Kassner Goodspeed Architects Ltd. has applied for substantive site plan approval to construct a five-storey mixed-use building with ground floor commercial and twenty-six residential units on lands located on Barrington Street between Kent Street and Tobin Street (Map 1 and Attachment A). To allow the development, the Design Review Committee must consider the application relative to the Design Manual within the Downtown Halifax Land Use By-law (LUB).

<b>Subject Site</b>	1144, 1148, and 1150 Barrington Street, Halifax
<b>Location</b>	On Barrington Street between Kent Street and Tobin Street
<b>Zoning (Map 1)</b>	DH-1
<b>Lot Size</b>	~776 square metres (~8355 square feet)
<b>Site Conditions</b>	Relatively flat with 3 existing commercial/residential buildings
<b>Current Land Use(s)</b>	Residential and Commercial
<b>Surrounding Land Use(s)</b>	A mix of commercial and residential land uses, including: <ul style="list-style-type: none"><li>• Medium and high-density residential buildings to the north;</li><li>• Low density residential dwellings to the south and west; and</li><li>• Retail grocery and gas bar (Superstore) to the east.</li></ul>

# Attachment A: Site Plan Approval Plans

CASE 22511 **EAST ELEVATION**  
THE OLYMPIC 1144 - 50 BARRINGTON ST.

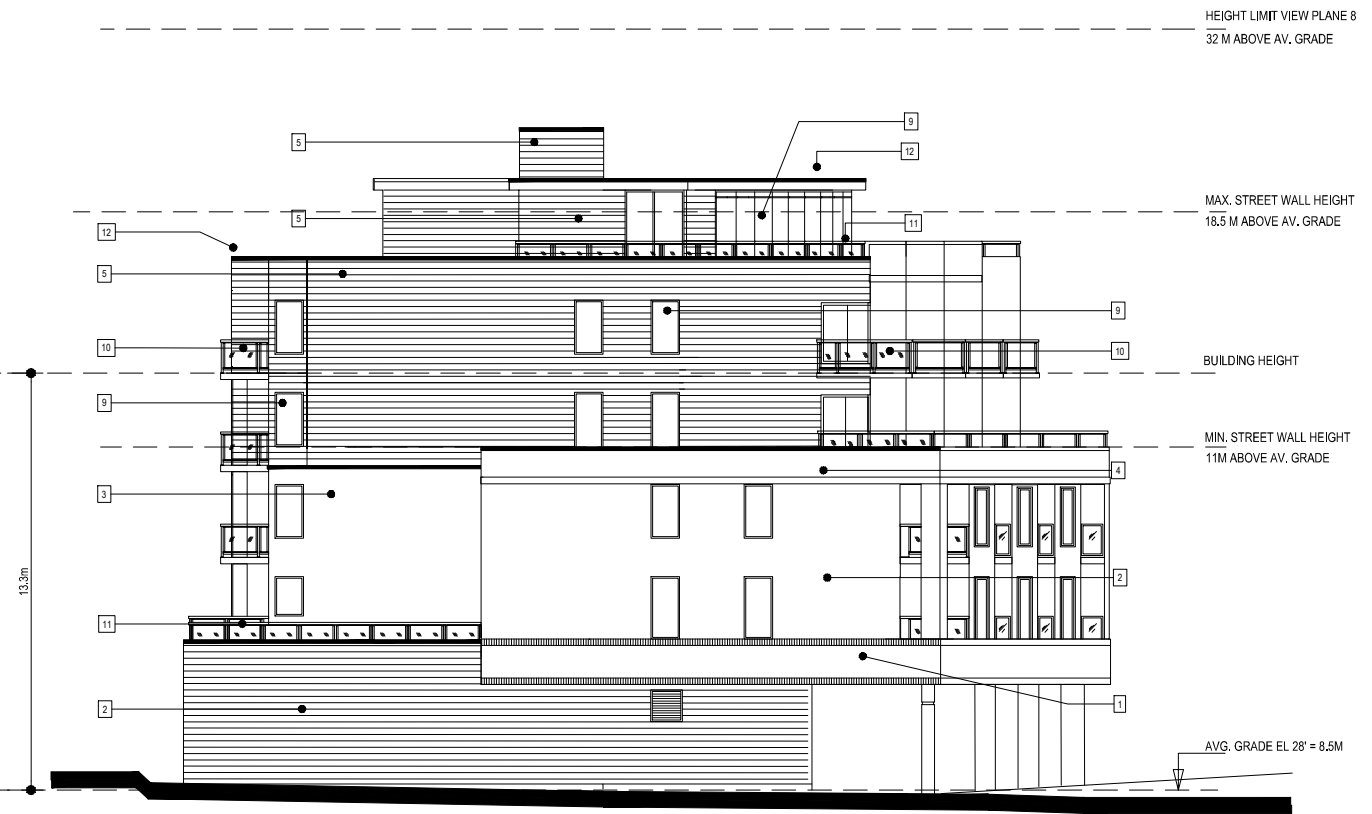
1. east elevation: to permit a setback of 8.5 metres (~30% of lot width) to accommodate the recesses for the garage and residential entrances;

On the ground level, the maximum setback could not be met from the south property line due to the recess created for the garage and pedestrian entrance. On levels 2 and 3 facing the west property boundary, the portion of the building that exceeds the maximum setback is only five feet wide and is the result of a building design intended to reduce the apparent scale of the wall adjacent to the neighboring house. Again, on levels 2 and 3, at the southwest corner of the building facing the south property line, the balconies are set into a notched corner that articulates the upper floors and establishes an appropriate setback distance for the balconies from adjacent properties. These variations are considered minor and do not negatively impact abutting properties. The setback distances are required to provide enough area for functional balconies while maintaining reasonable setbacks. As such, staff recommends approval of this variance.

CASE 22511 **WEST ELEVATION**  
THE OLYMPIC 1144 - 50 BARRINGTON ST.

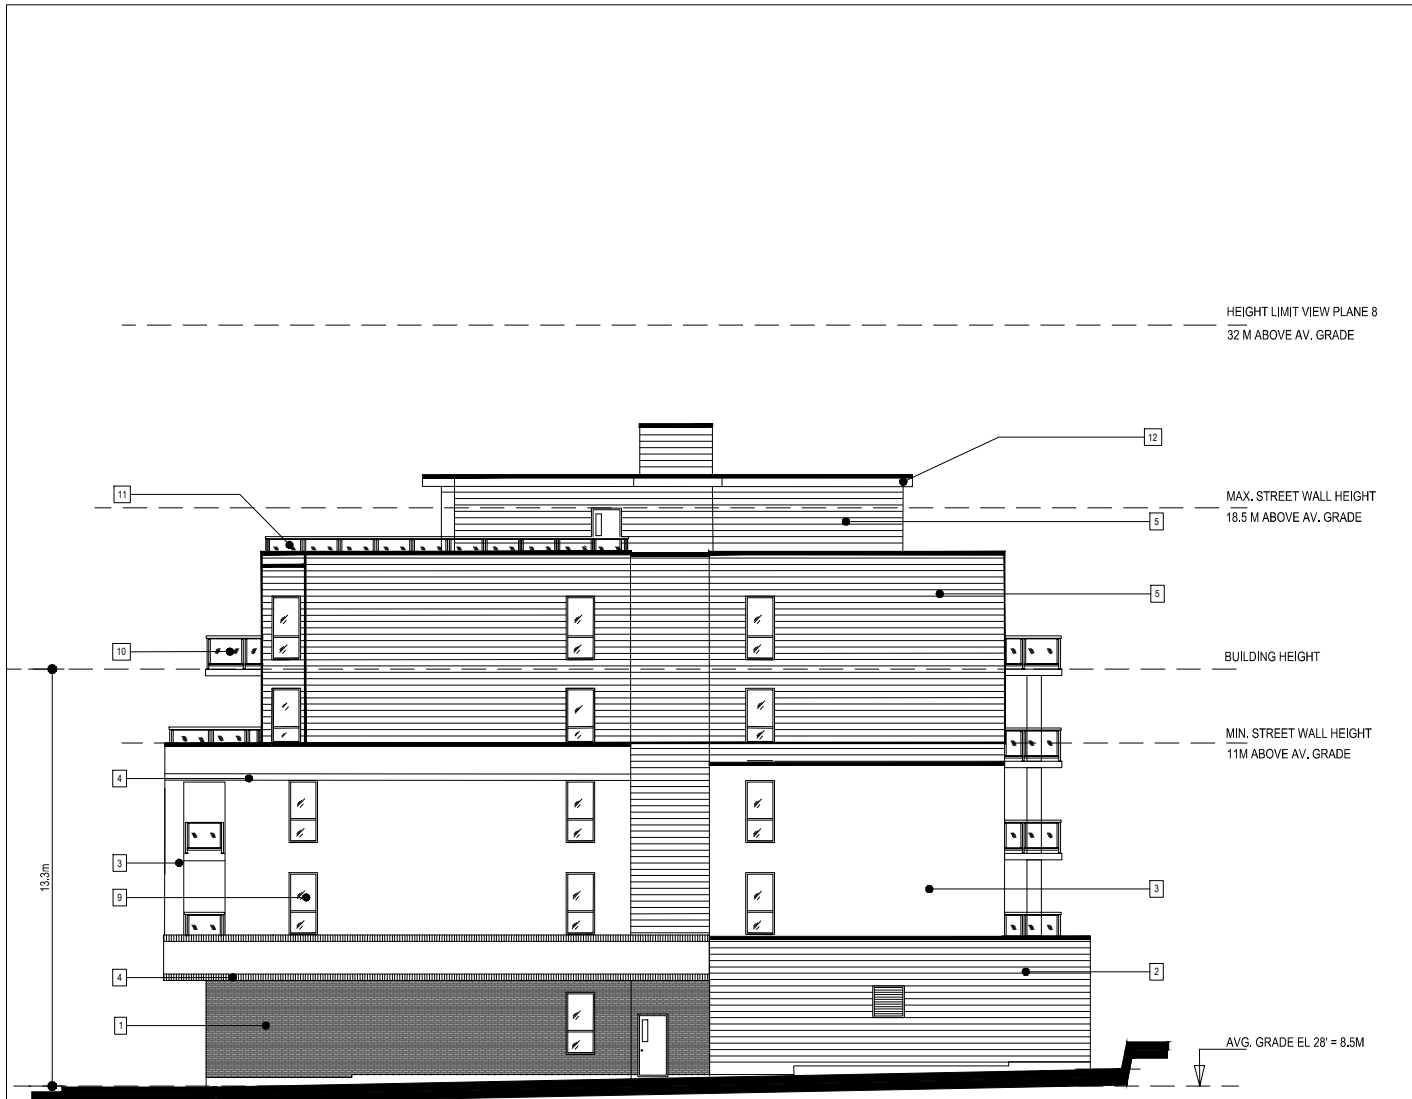
2. west elevation: of levels 2 & 3 a setback of 7.1 metres (~25.7% of lot width) is proposed from the south property line to provide suitable interaction with the low-density residential uses; and
3. south elevation: on levels 2 & 3 the building setbacks creating a west face that requires a setback of 10.97 metres (~39% of the lot width) from the west property line to provide the balconies an appropriate separation distance from the property line.

CASE 22511 **NORTH ELEVATION**  
**THE OLYMPIC 1144 - 50 BARRINGTON ST.**

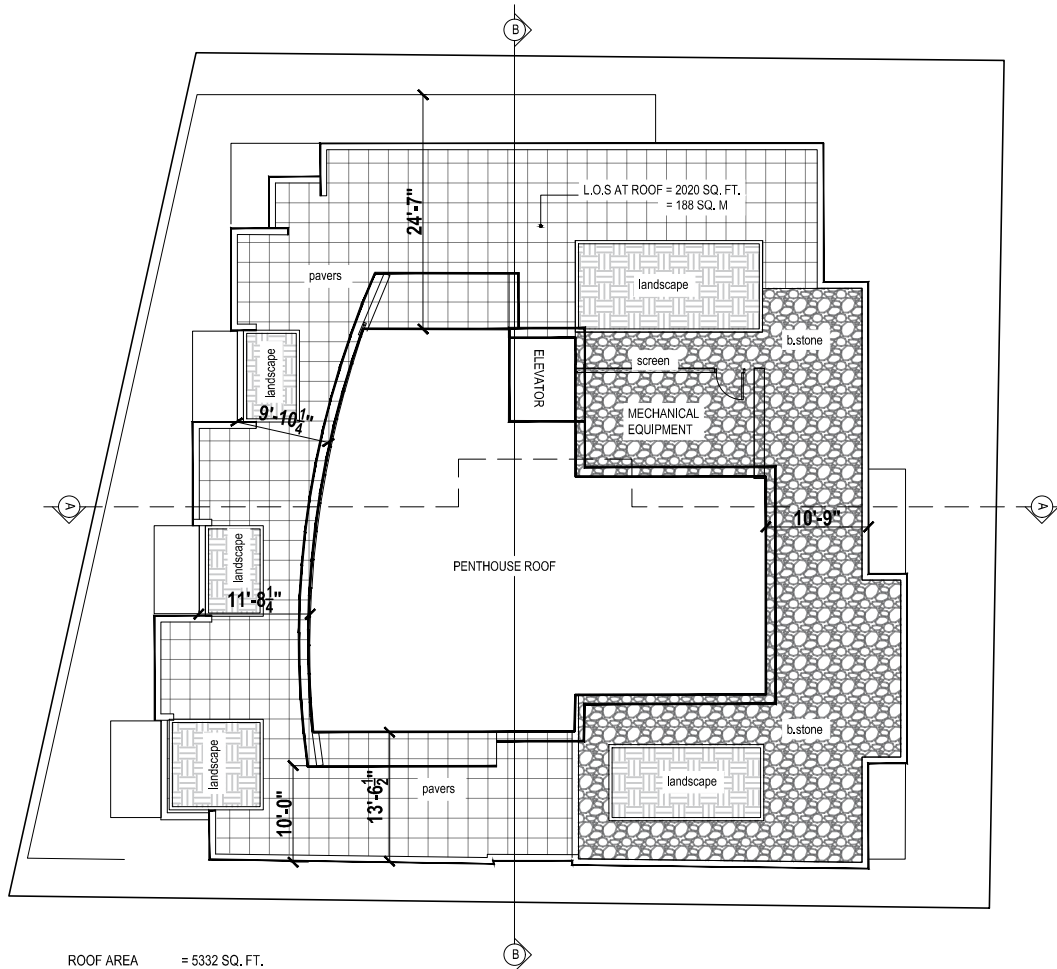
Section 10(4) of the LUB requires a minimum setback of 10% (2.76 metres) of the lot width from interior lot lines for the mid-rise portion of the building. Section 10(14) of the LUB allows the consideration of a variance where the relaxation is consistent with the Design Manual. The applicant has requested a variance to this requirement to permit a setback of 1.2 metres on the north elevation.

The applicant has stated that the minimum setback from the north property line for the mid-rise portion of the building could not be met because of modest site dimensions, coupled with the attempt to configure the service cores efficiently and step the building back further from the lower density residential uses on the south and west property lines. The north façade faces an open parking lot and therefore a reduced setback is considered minimal and does not negatively effect separation distances to the abutting structure. Furthermore, the overall height of this building is approximately 10 metres below the maximum permitted height and the proposed setback relaxation is 1.5 metres. This results in a setback reduction of approximately 15% of the building height reduction which is consistent with the variance criteria set out in part 3.6.6 b of the Design Manual. As such, staff recommends approval of this variance.

*Non Compliance:* There is one area of non-compliance. On North façade, the step back of upper floors 4 and 5 is 1.2m from the interior lot line.
